GWF Hanford Combined Cycle Amendment

Soils and Water Resources Data Response Clarifications

The following clarifications are responses to comments provided by Mark Lindley on February 19, 2009 and discussion held between the CEC and GWF on March 3, 2009.

Attachment DR3.2-27-2 GWF Hanford Basin Design Areas

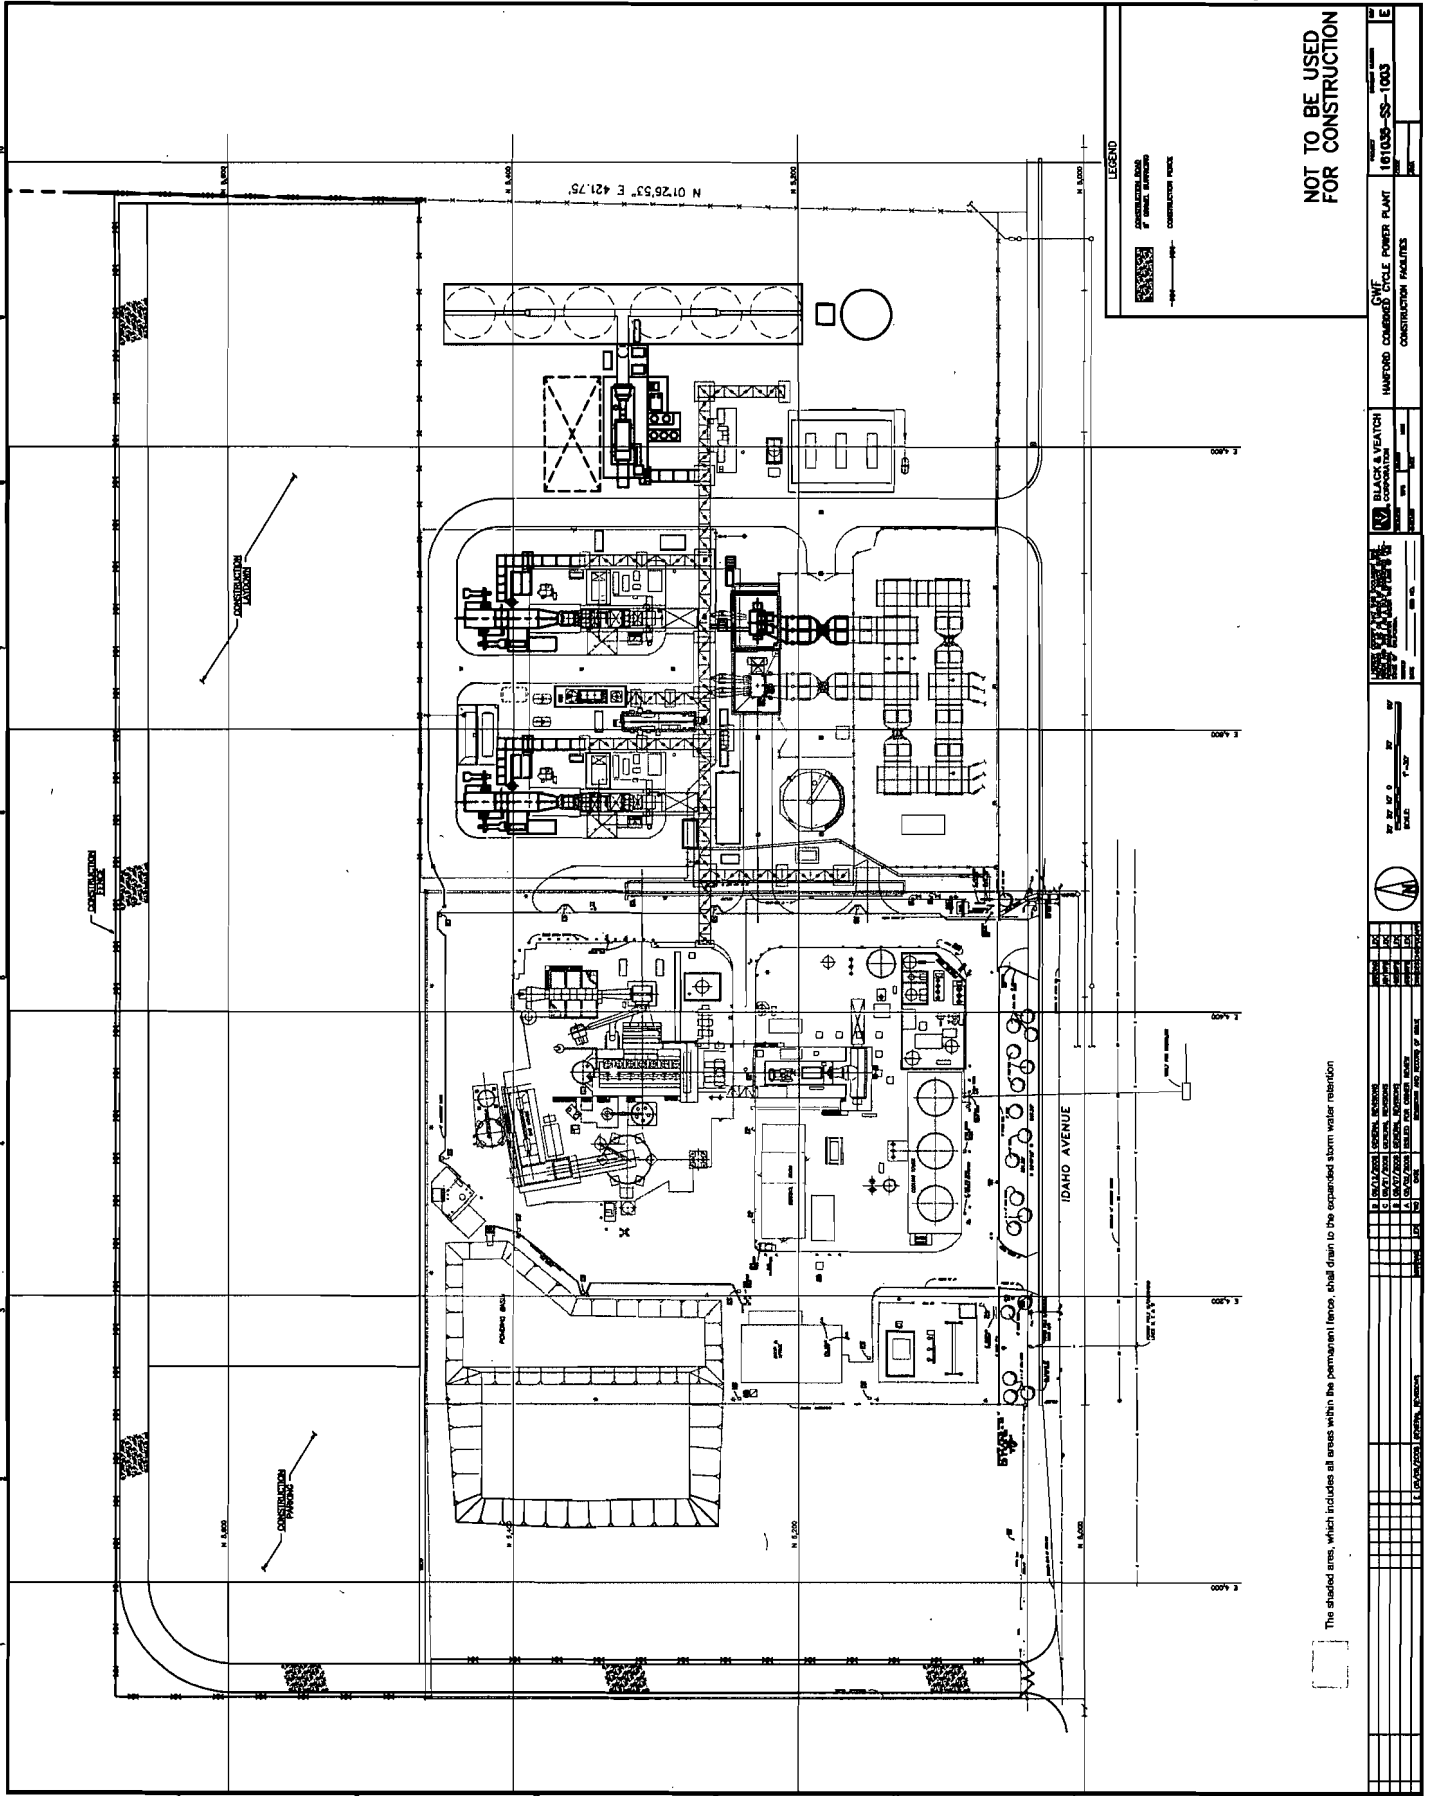
GWF calculated the required stormwater retention basin volume for all areas within the permanent fence. The calculation can be found in Attachment DR3.2-27.1. The permanent area was broken up into three distinct areas with different runoff coefficients. The areas are identified in Attachment DR 3.2-27.2. The estimated required retention basin volume was 143,730 cubic feet versus the proposed total volume of 158,243 cubic feet.

-  The areas shaded in red are the industrial areas of the power plants.
-  The area shaded in blue is the storm water retention basin.
-  The area shaded in green is a dirt field used as permanent laydown area.

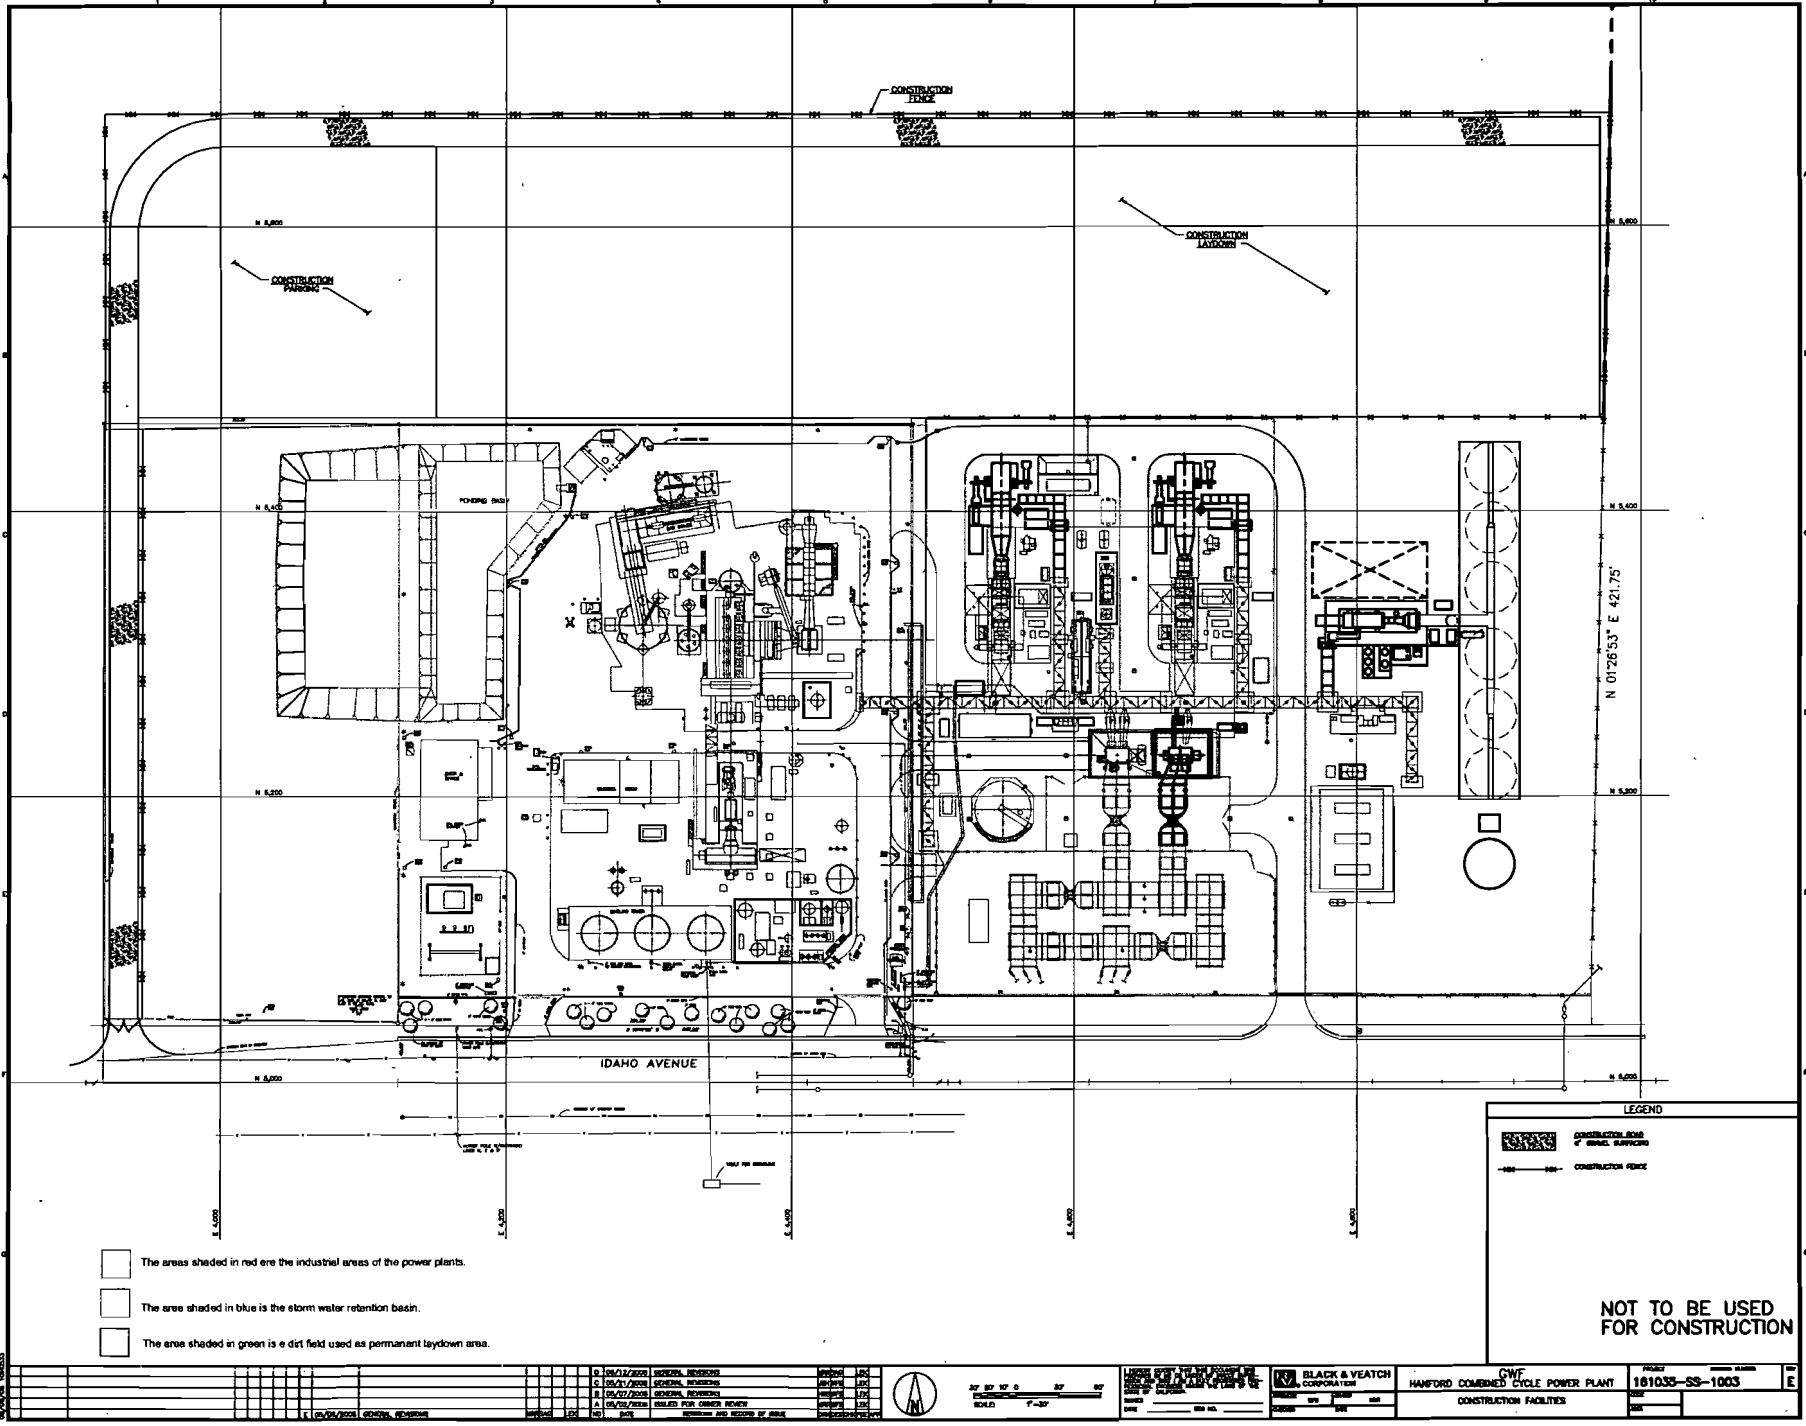
The contributing watershed has been highlighted in Attachment DR3.2-26. All areas within the permanent fence shall drain to the expanded stormwater retention basin.

The shaded area, which includes all areas within the permanent fences, shall drain to the expanded storm water retention
